Customer board layout (TPS5430) and their problem

Customer's countermeasure and result of their board

Waveform at Iout:1A on customer board

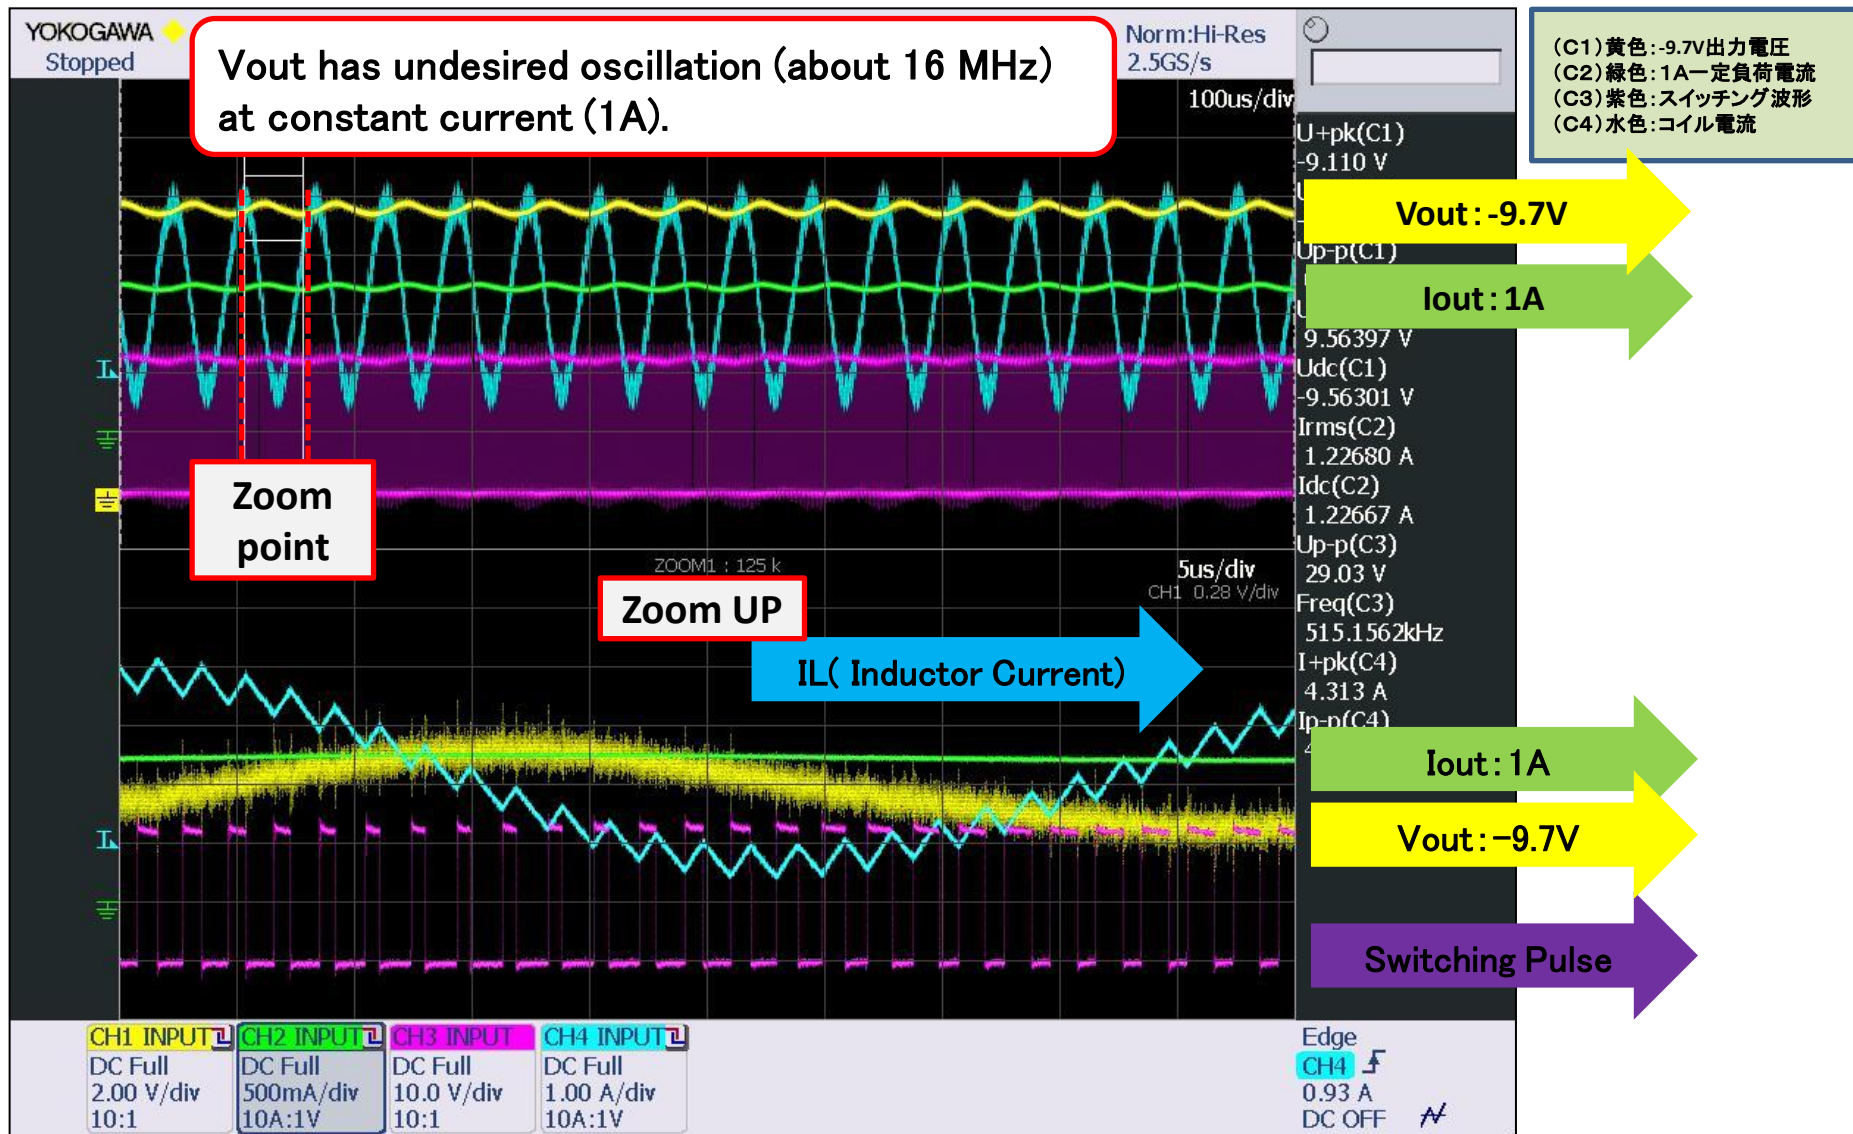
- ①An undesired oscillation of V_{out} was confirmed with a constant current.
(Especially, undesired oscillation is remarkable with the high load current.)

Under the situation, this problem occurred when a customer cooled these parallel capacitances of the output side with a cold wind.

- ③Although the low load current, this problem occurred when its part was cooled.

考察: 負荷が大きくなると発振することは分かっている。・・・定常(一定)負荷で起きる。
コイルに流れる電流が通常発振周波数では無い所で周期的(約16kHz)で変動しているのが分かる。

Waveform at Iout:1A after their countermeasure

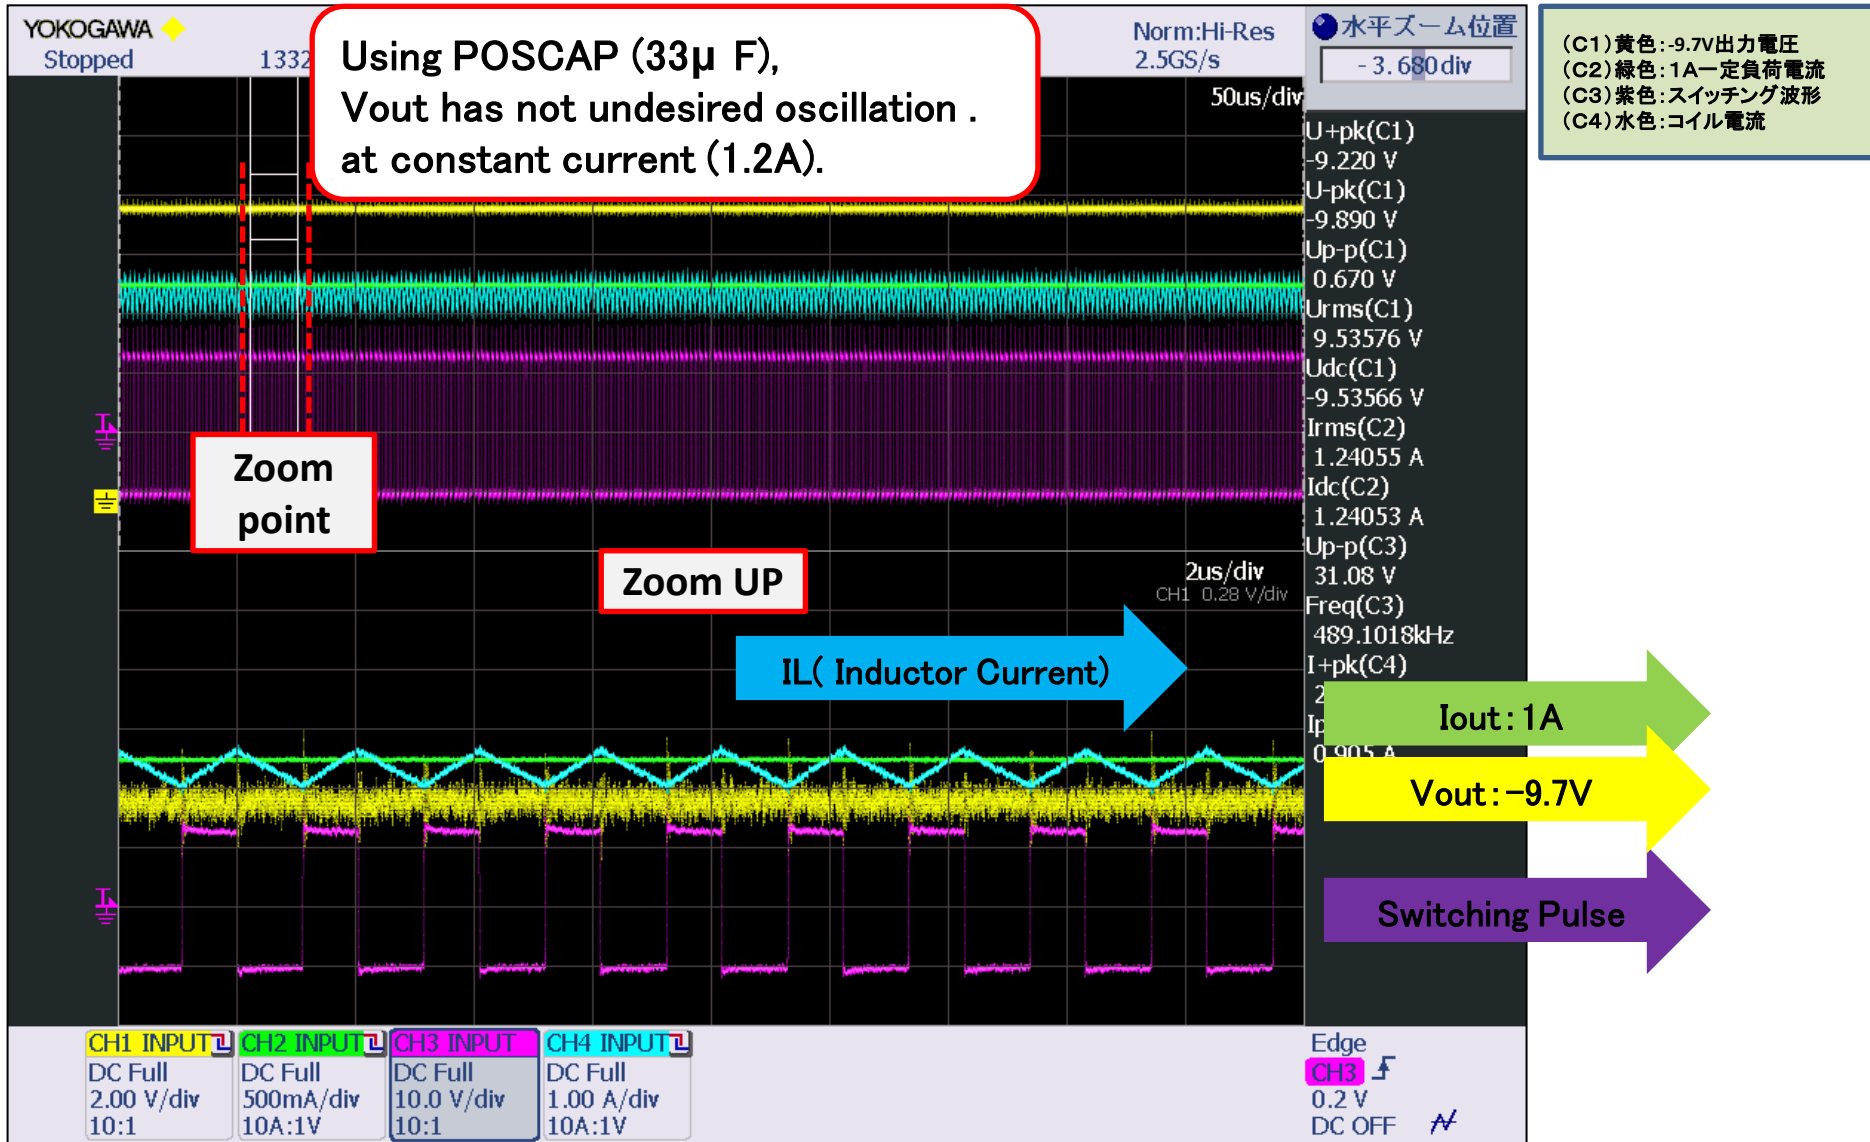
Customer tried a change of these input capacitances. (value/kind)

These points are C1235 and C1236 on customer's block diagram.

Before Ceramic capacitance 4.7μ F

After POSCAP 33μ F

Even if low temperature and high load current, this undesired oscillation did not occur.

考察: 出力波形、コイル電流、それにスイッチング波形に異常は見当たらない。
